Project Name: Bed Bath and Beyond Plaza / Enterprise Rent A Car

SITE PLAN REVIEW AND APPEARANCE BOARD STAFF REPORT

File No.: 2019-157-SPM-SPR-CL3

Application Type: Class III Site Plan Modification

PHOTOMETRIC & ELECTRICAL SITE PLAN EXISTING CONDITIONS

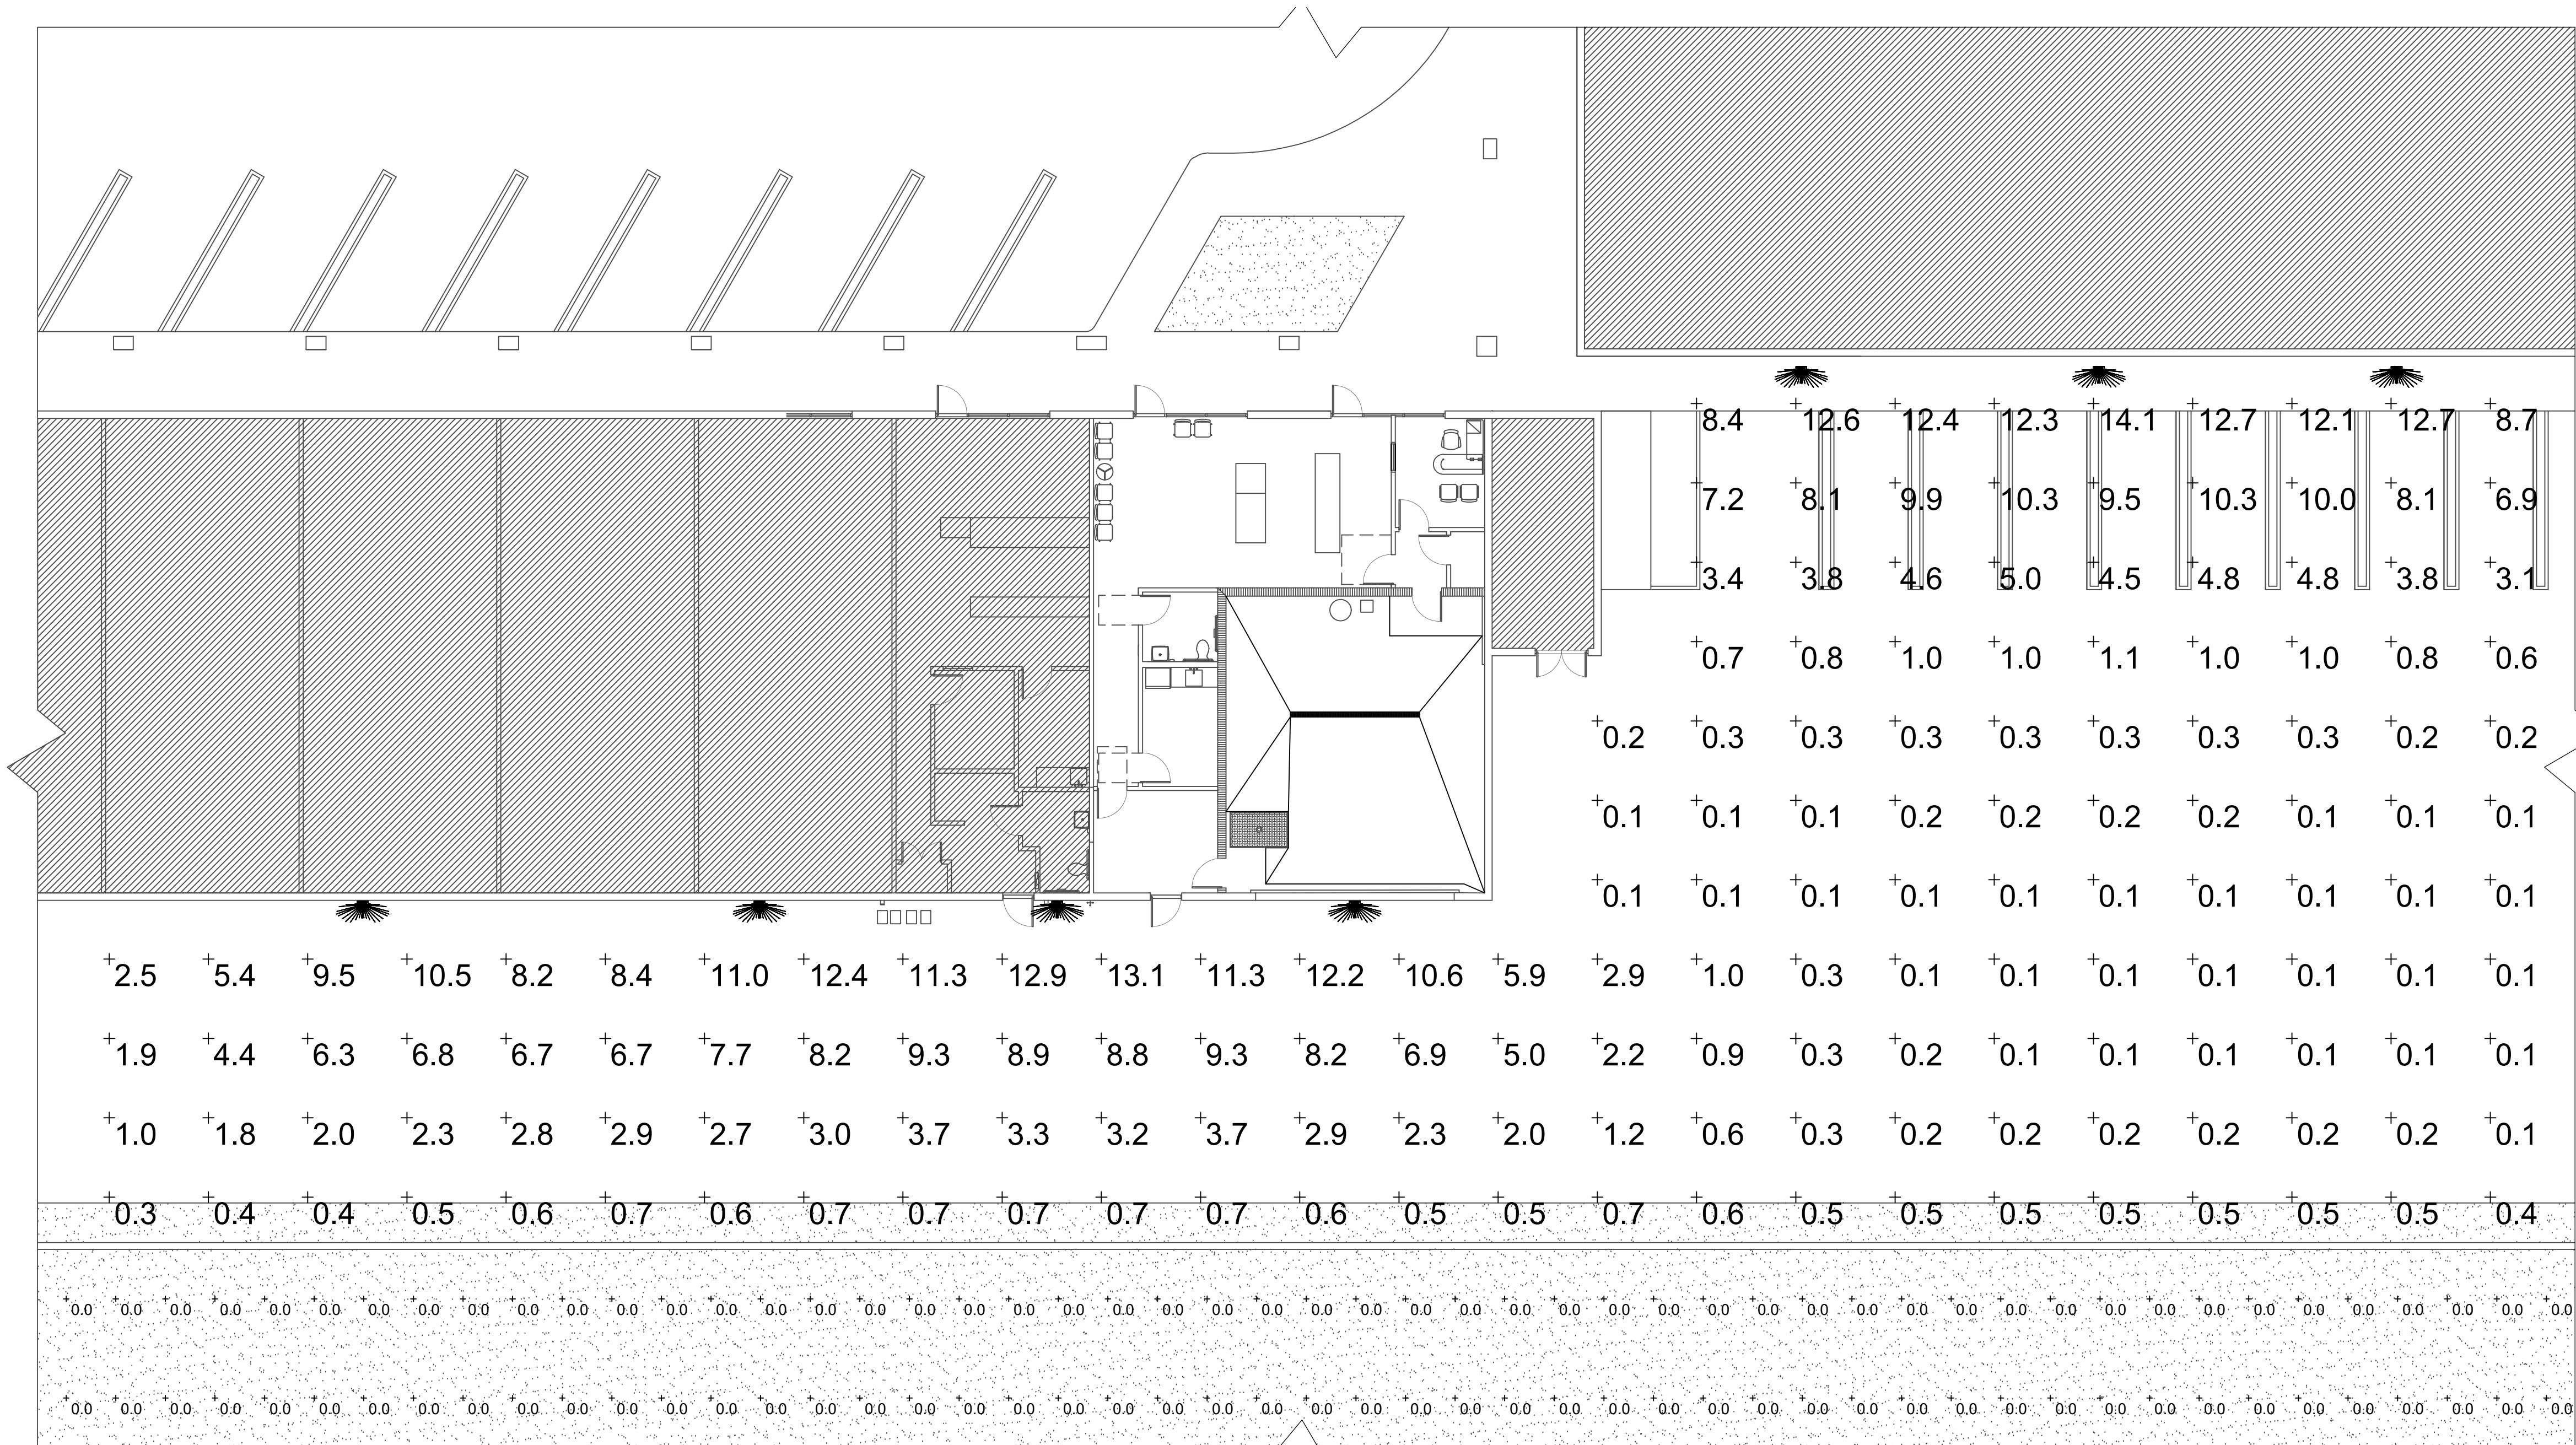
The photometric plan provided does not provide the illumination levels for the area designated for storage of vehicles at the rear of the property. A revised photometric plan shall be provided in accordance with the required illumination levels per LDR Section 4.6.8 for parking lot prior to the certification of the plans. If additional fixtures are required, they will be required to be full-cutoff luminaries on the perimeter of the property.

- The proposed artificial material used to screen the refuse disposals shall be replaced if damaged, weathered or fails to properly screen the refuse area.
- A revised Photometric Plan shall be provided in accordance with LDR Section 4.6.8 prior to certification of the plans.
